Planning Application No: 3/2021/1153 Grid Ref: 376632 444055

Proposal: Proposed dwelling with basement accommodation on an in-fill site adjacent to no 9 Old Road Chatburn, following refused applications 3/2019/0498 and 3/2020/0145.

Location: land adjacent to no 9 Old Road Chatburn BB7 4AB

Figure 5. Looking north across restored areas in the northern section of the Application Site.

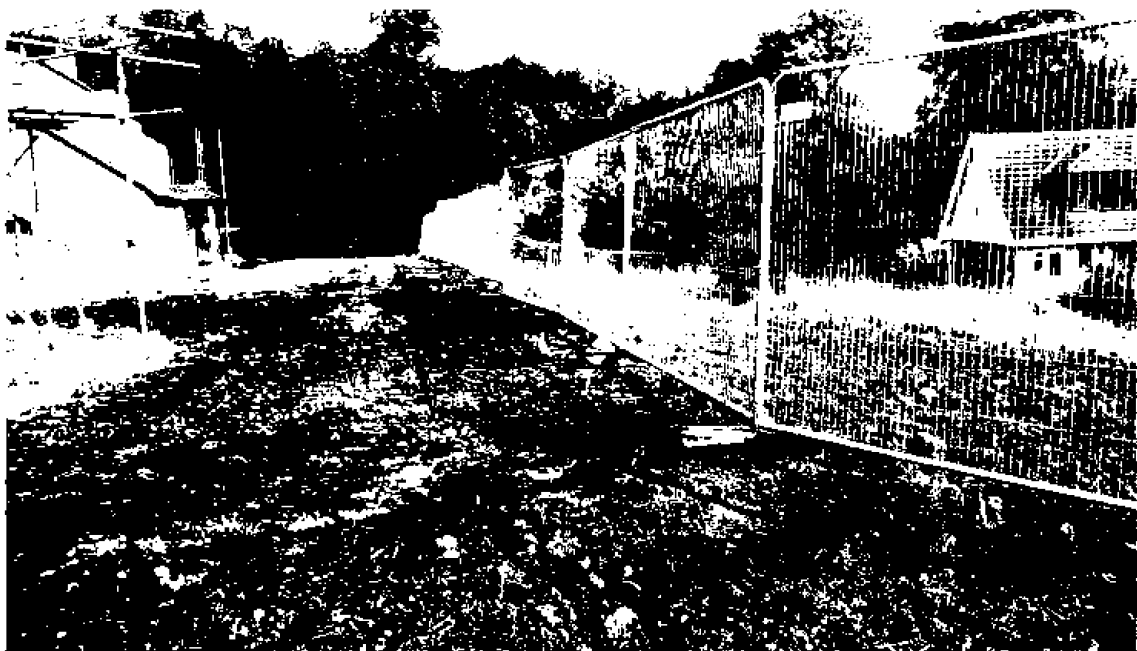
In addition to the Google Earth Images above showing areas of the original habitat that are unaffected by the infilling of imported soils, the applicant submitted photographs as part of planning application LCC_2017_0087. Figure 5 from this planning application is as below and shows areas of the original habitat that are not affected by the filling activity.

Figure 5. Looking north across restored areas in the northern section of the Application Site

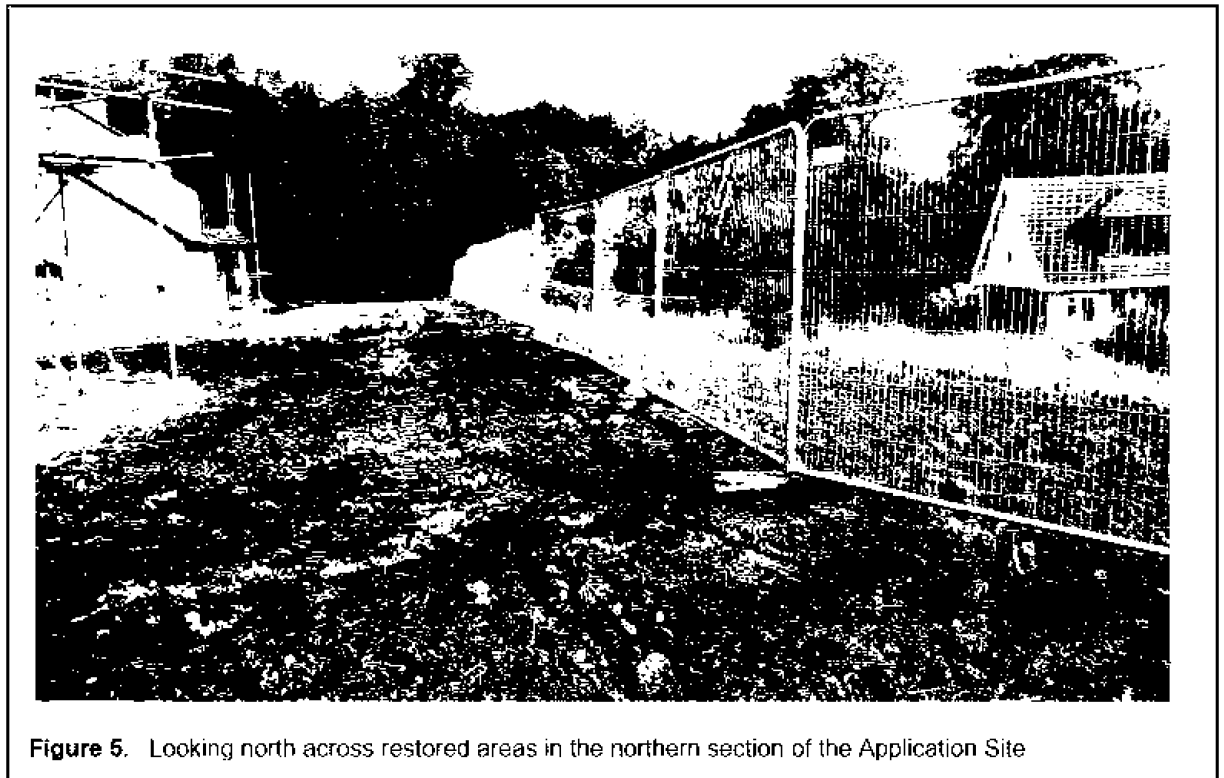
In addition to the Google Earth images above showing areas of the original habitat that are unaffected by the Infilling of Imported soils, the Applicant submitted photographs as part of planning Application LCC_2017_0087. Figure 5 from this planning Application is shown below and shows areas of the original habitat that are not affected by the soils filling activity.
